Revised type plan for a combined dispensary and in-patients wards —

Sanctions Revised type plan —

MODIFIED TYPE DESIGN FOR THE LOCAL FUND.

G. O. No. G. 2215-33/Med. 77-26-21 Bangalore, Dated, the 26th August 1927.

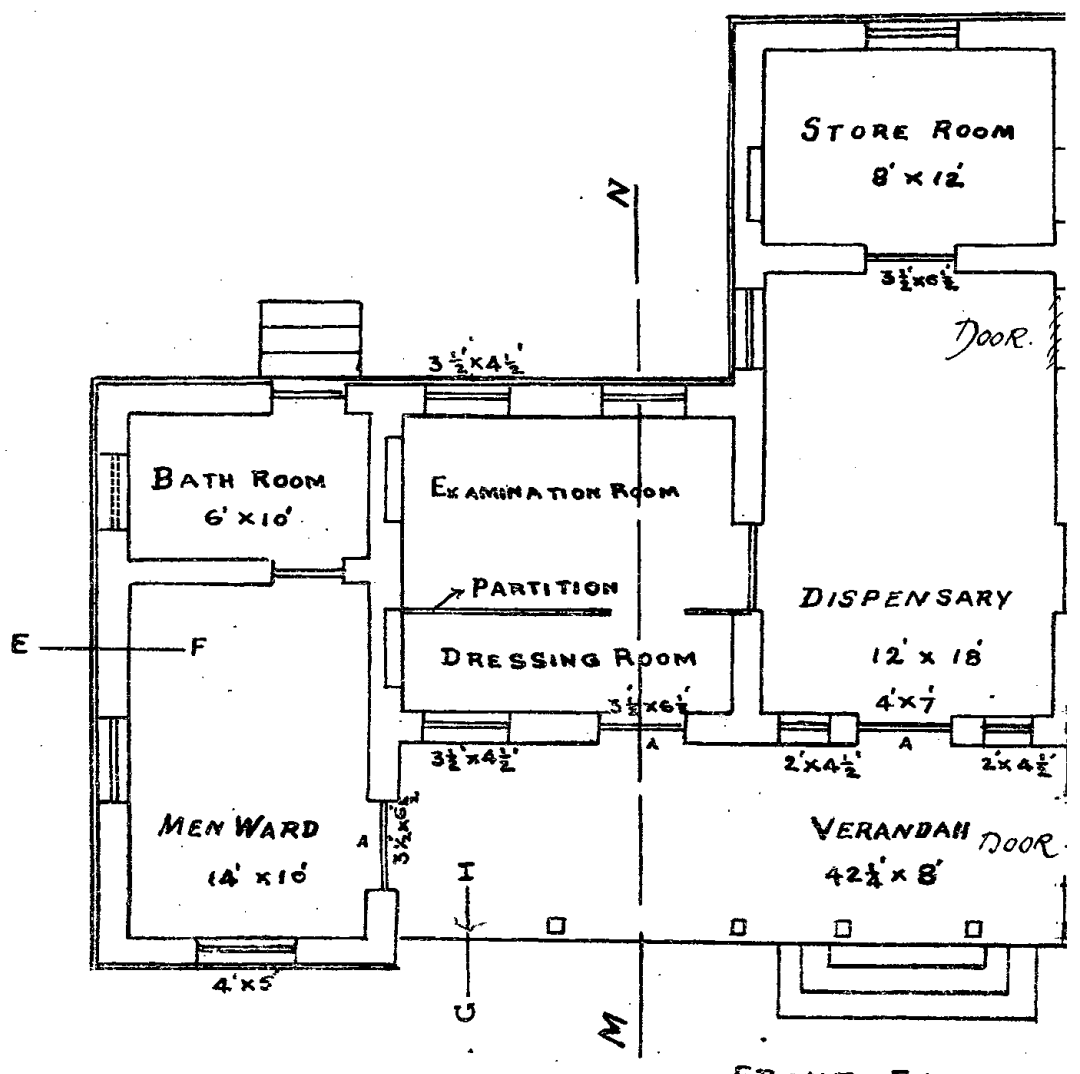
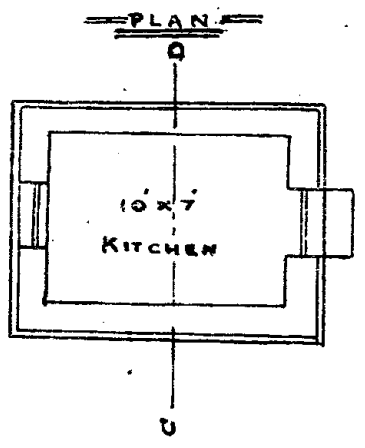
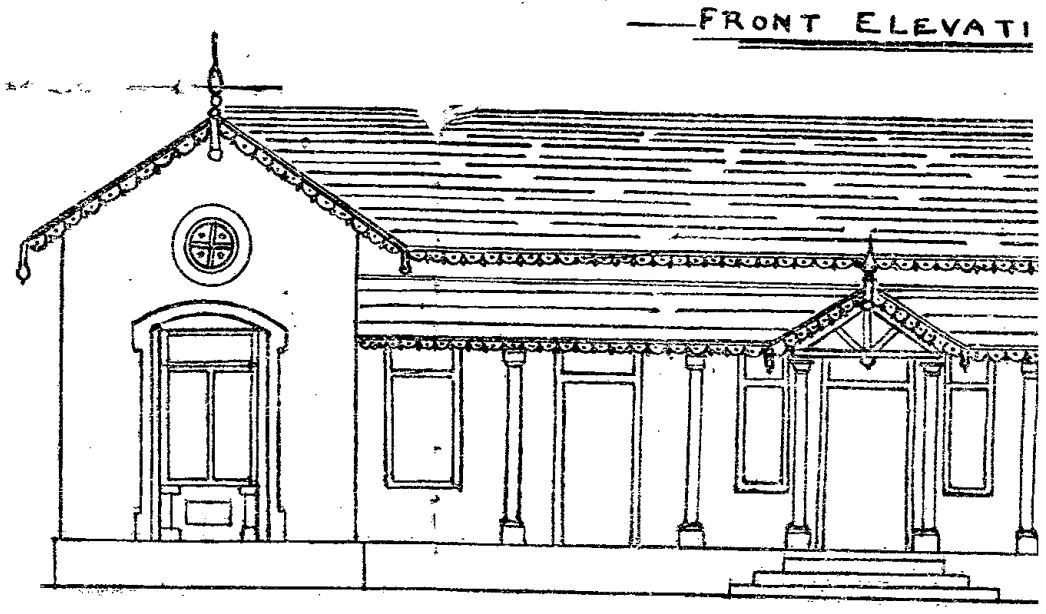
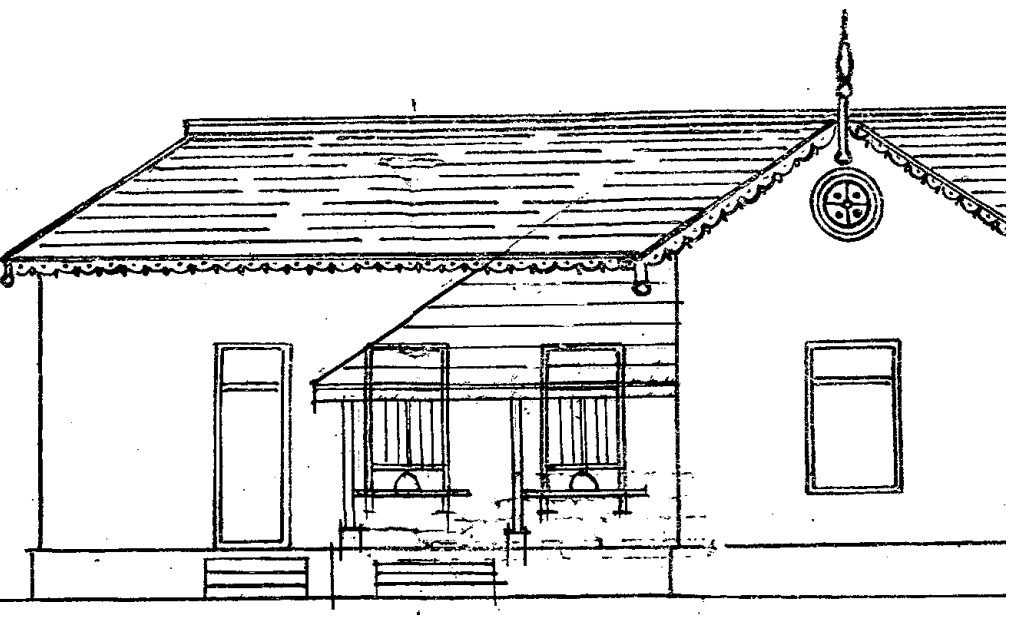
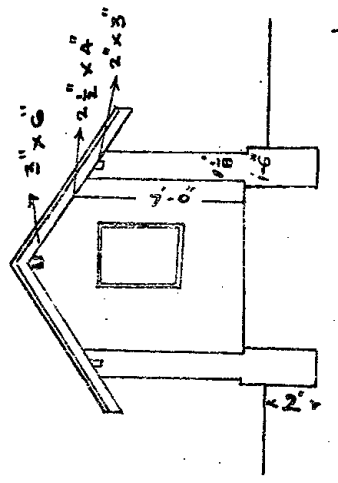
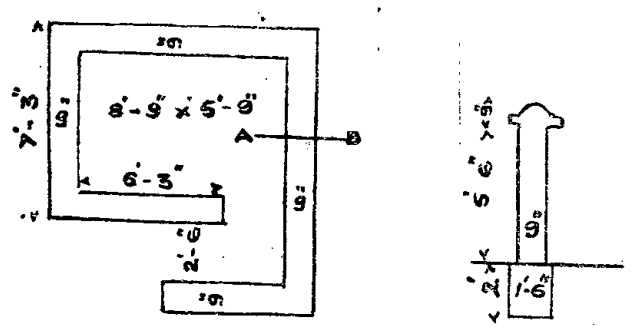
As desired in your letter No.N.G.C.238-1, dated the 10th December 1926, I have the honour to forward herewith, a typeplan of the local Fund Dispensary marking thereon, in red colour, the proposed waiting room for female patients in the front verandah by screening off a portion of the same andadding a new verandah in the rear portion of the building for the dispensary counters to issue medicines from the compounding room.

I have the honour to forward herewith a blue print of the existing type design of the Local Fund Dispensaries in the State making thereon in red colour the proposed waiting room for women in the right hand corner of the front varandah by screening off a portion of the same. A new ~~MAY~~ doorway in the Dispensary has been provided in place of a window as shown in the plan to afford access from the prescribing room direct to the compounding room. Steps are also provided at the extreme right end of the Varandah for the exit of patients after obtaining medicines, so that they may not have to go through the Prescribing Room or the Waiting Room once again.

I have the honour to forward herewith a blue print of the existing type design of the L.F. Dispensaries in the State making thereon in red colour the proposed waiting room for women in the right hand corne of the front varaydah by screening off a portion of the same. A new doorway in the Dispensary has been provided in place of a window as shown in the plan to afford access from to the prescribing room direct to the Compounding Room. Stone Steps are also provided at the extreme right end of the varandah for the exit of the patients after obtaining medicines, so that they may not have to go through the prescribing room or the waiting room once again. Separate counters for issue of medicines to Male and Female patients have been provided as shown in the plan.

The correct title should be "Local Fund Dispensary with In-patients' Wards."

Government are pleased to approve of the modifications suggested by the Senior Surgeon in the type design of L.F. Dispensaries to be constructed in future.

Government are pleased to approve of the modifications suggested by the Senior Surgeon in the type design of Local Fund Dispensaries to be constructed in future.
